Source: SA WG3
Title: 1 CR to 33.102: Removing the list of access type codes from authentication failure report (Rel-4)
Document for: Approval
Agenda Item: 7.3.3

Spec	CR	Rev	Phase	Cat	Subject	Version-Current	Version-New	Doc-2nd-Level
33.102	155	1	Rel-4	F	Removing the list of access type codes from authentication failure report	4.1.0	4.2.0	S3-010394

Title:	⌘ Removing the list of access type codes from authentication failure report		
Source:	⌘ S3		
Work item code:	⌘ SEC1	Date:	⌘ 27-06-01
Category:	⌘ F	Release:	⌘ REL-4
	<i>Use one of the following categories:</i> F (essential correction) A (corresponds to a correction in an earlier release) B (Addition of feature), C (Functional modification of feature) D (Editorial modification)		<i>Use one of the following releases:</i> 2 (GSM Phase 2) R96 (Release 1996) R97 (Release 1997) R98 (Release 1998) R99 (Release 1999) REL-4 (Release 4) REL-5 (Release 5)
	Detailed explanations of the above categories can be found in 3GPP TR 21.900.

Figure 13: Reporting authentication failure from VLR/SGSN to HLR

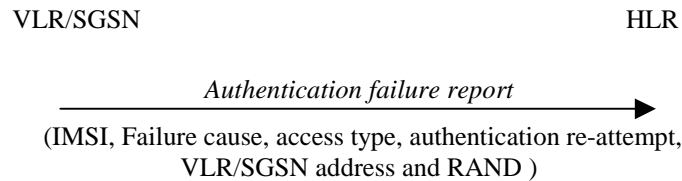
Reason for change: ⌘ The access type parameter in authentication failure report can only have values that may be used in CS-domain (e.g. location update). In addition to these, there are several access types that exist only in PS-domain (e.g. routing area update) To avoid updating the list when new access type codes need to be added, the exhaustive list is removed from this stage 2 specification and kept only in TS 29.002.

Summary of change: ⌘ Allowing the use of all possible access types in authentication failure report

1. Subscriber identity;
2. Failure cause code. The possible failure causes are either that the network signature was wrong or that the user response was wrong;
3. Access type. This indicates the type of access that initiated the authentication procedure if the authentication procedure was initiated due to a call set up, an emergency call, a location updating, a supplementary service procedure or a short message transfer;
4. Authentication re-attempt. This indicates whether the failure was produced in a normal authentication attempt or it was due to an authentication reattempt (there was a previous unsuccessful authentication);
5. VLR/SGSN address;
6. RAND. This number uniquely identifies the specific AV that failed authentication.
